Subject: Borel Middle School HVAC Replacement
San Mateo - Foster City School District
Aedis Project No. 2021005
DSA Application #01-119557

ADDENDUM NO. 1

SHEET # AD1-
A1.02

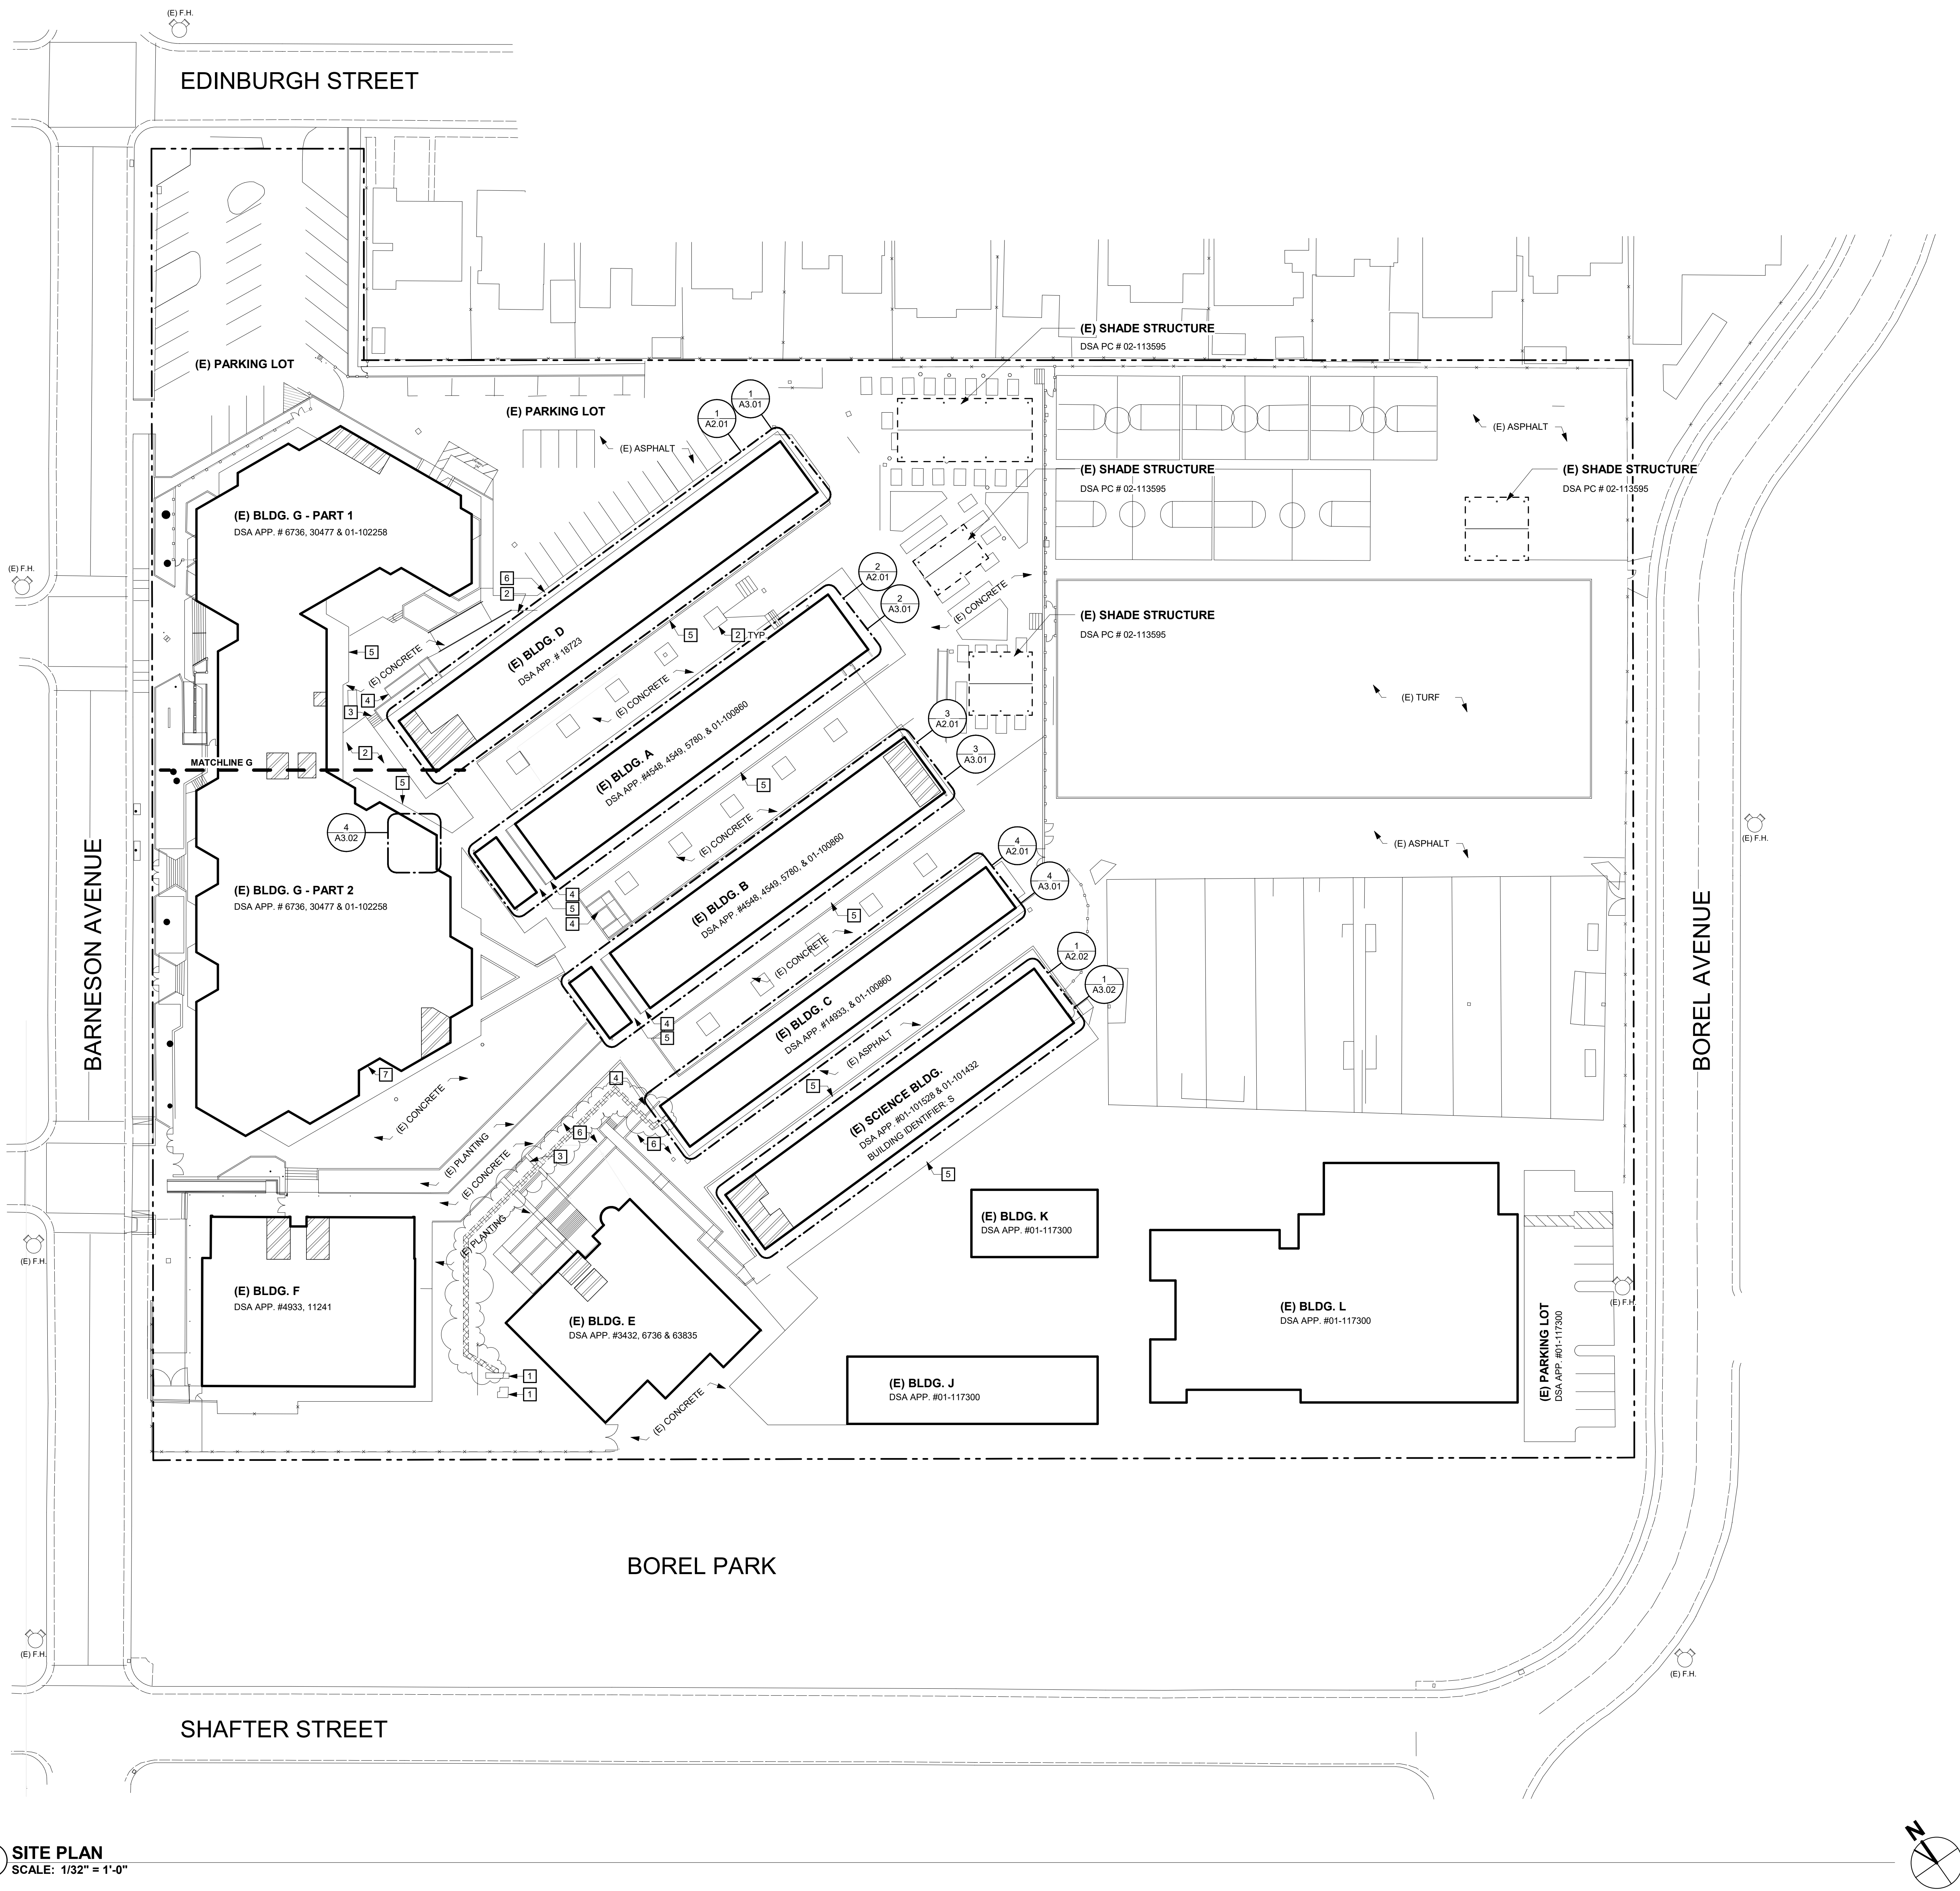
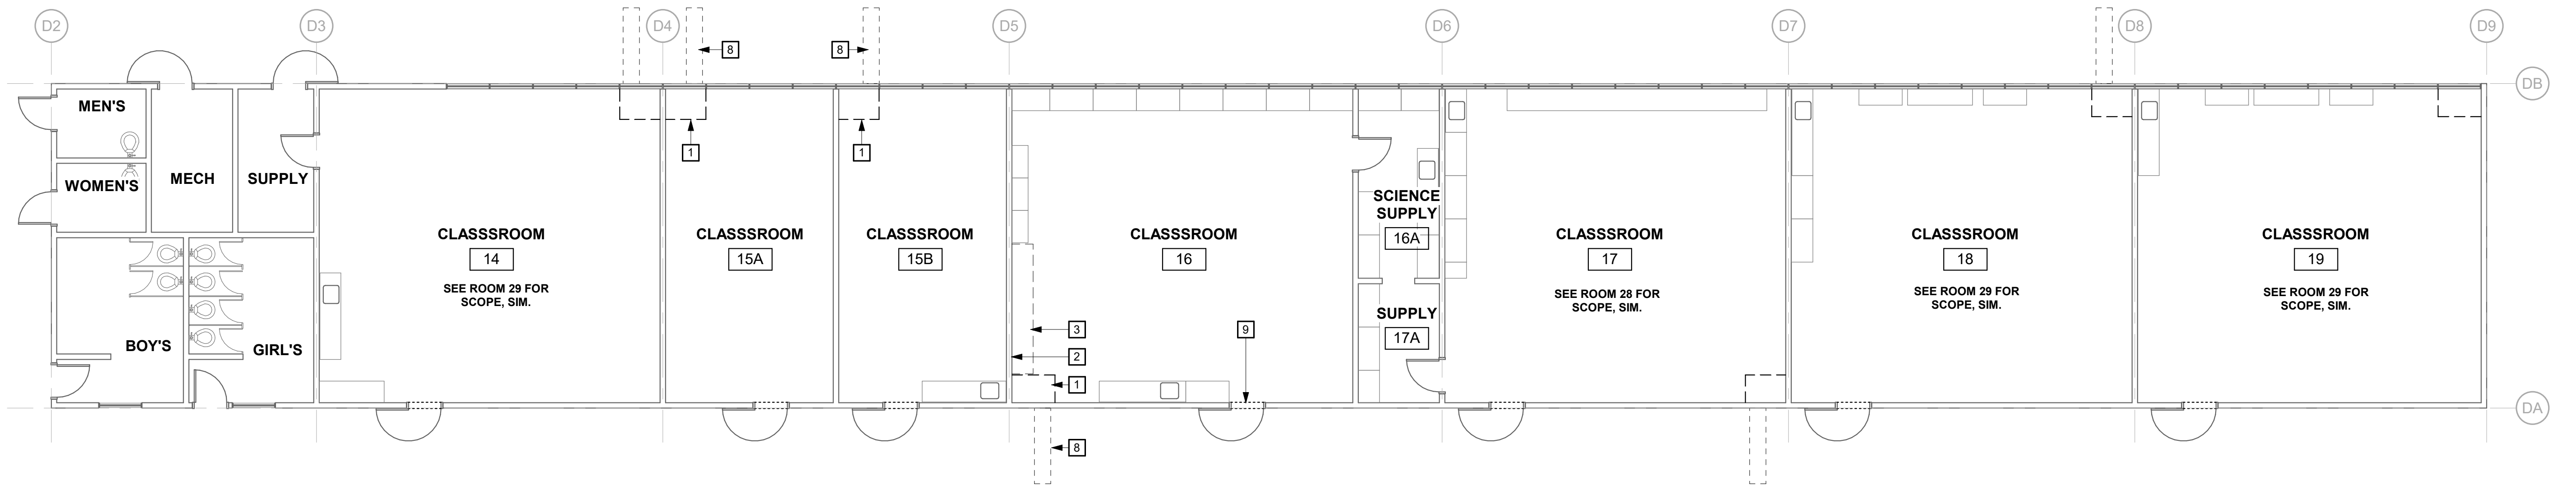
Add: Trench area to New Site Plan 1/A1.02 & Graphic Key per AD1-A1.02

AD1-

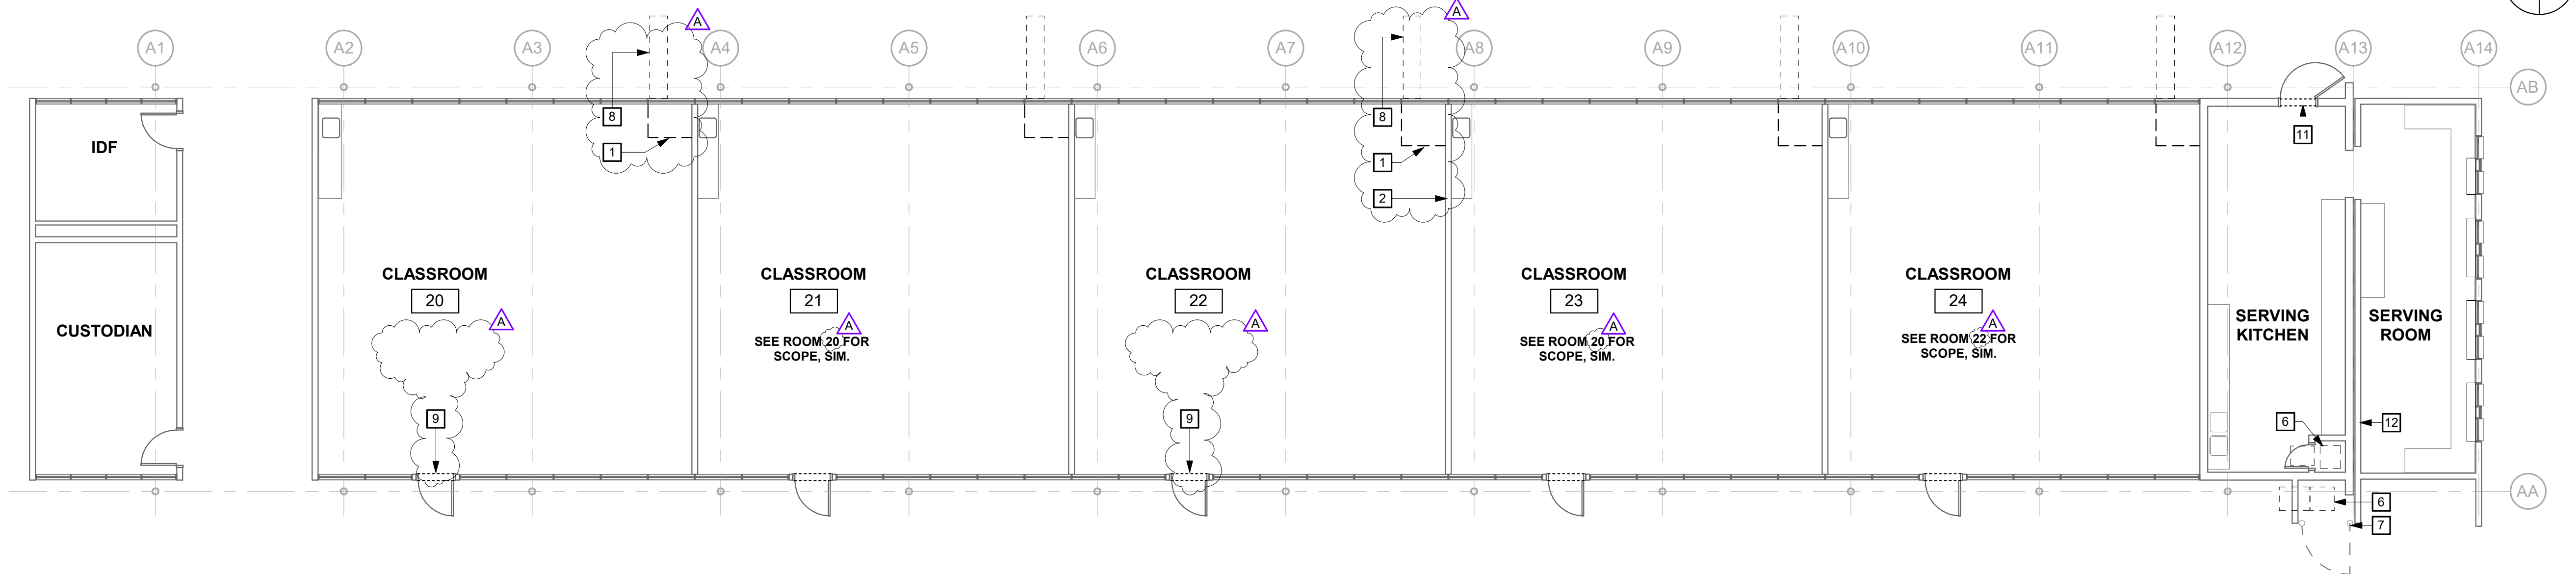
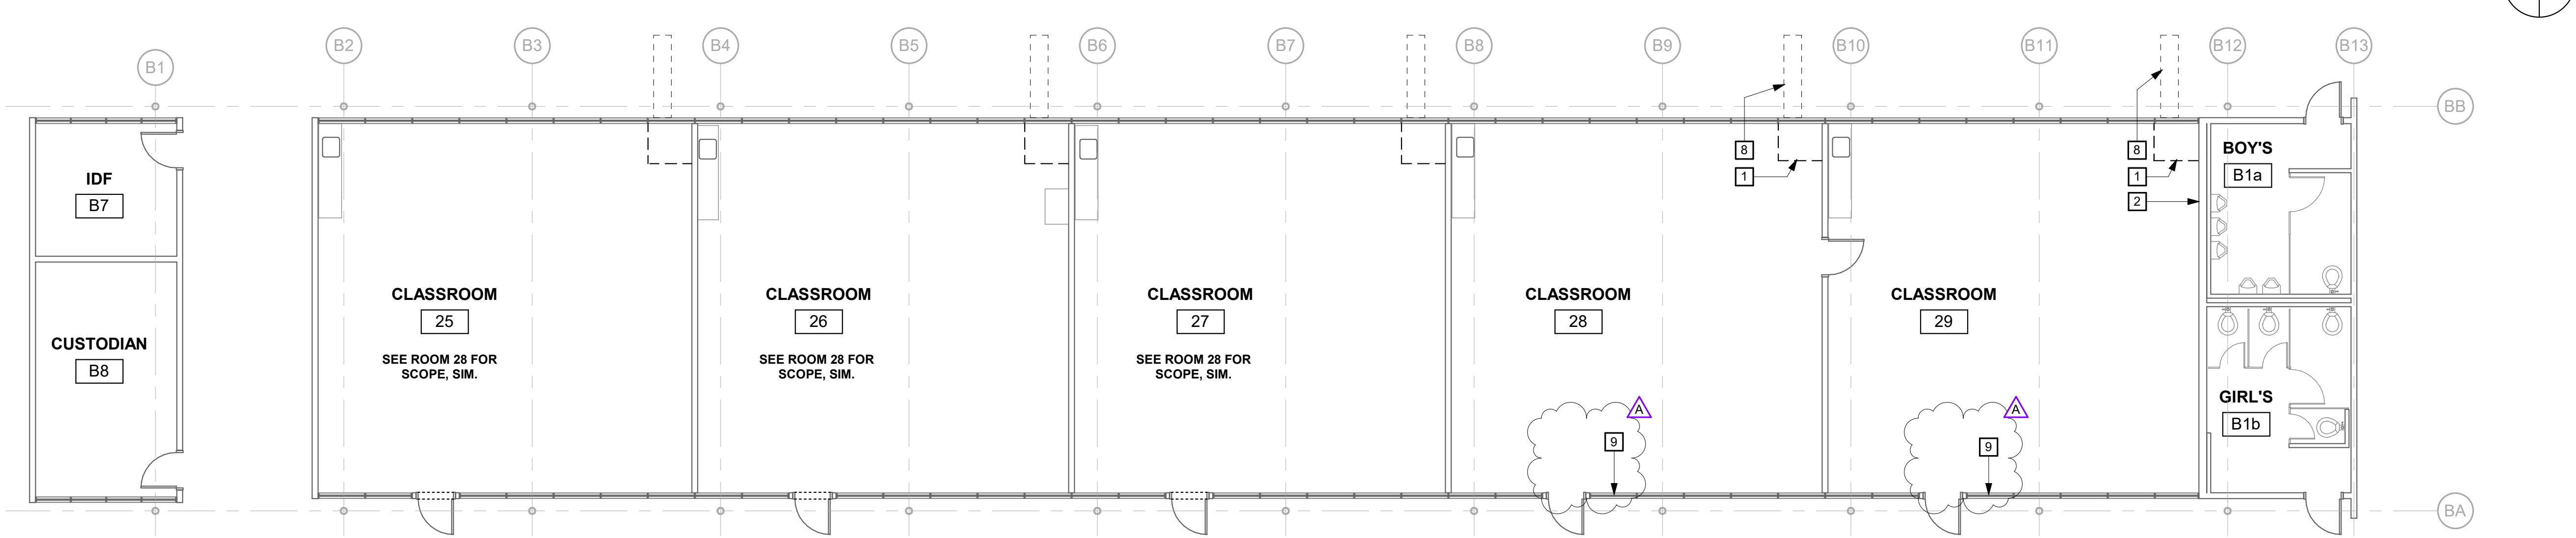
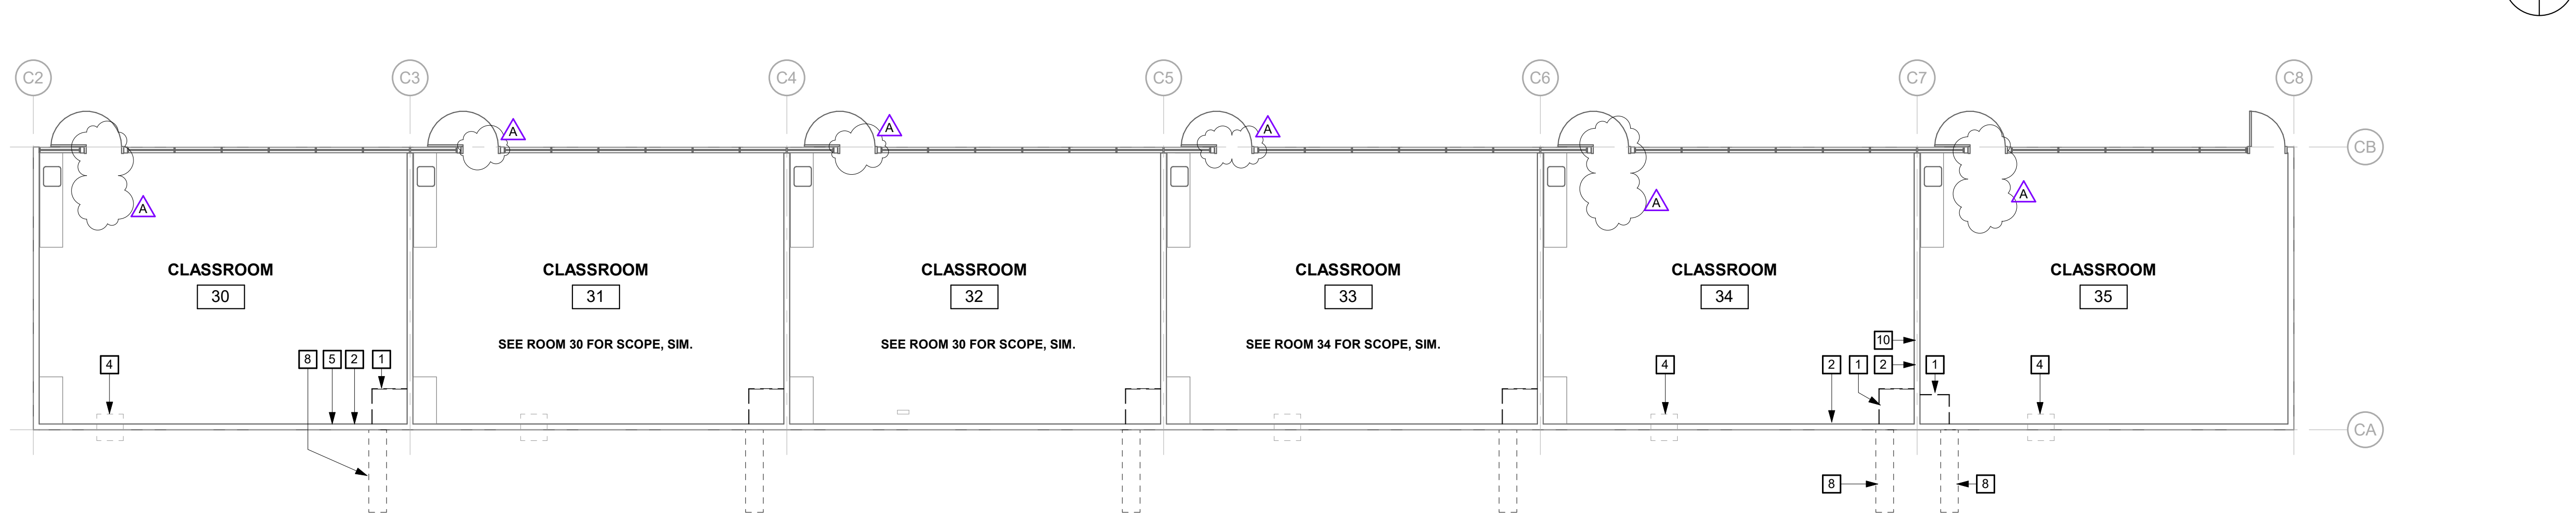
- Revise: Reference room 20 for similar scope where occurs in Demolition Floor Plan 2/A2.01 per AD1-A2.01
- Revise: Keynote scope for classrooms 20 and 22 in Demolition Floor Plan 2/A2.01 per AD1-A2.01
- Add: Keynote 9 in Demolition Floor Plan 3/A2.01 per AD1-A2.01
- Remove: Keynote 9 in Demolition Floor Plan 4/A2.01 per AD1-A2.01
- Add: General Sheet Note #J PER AD1-A2.01
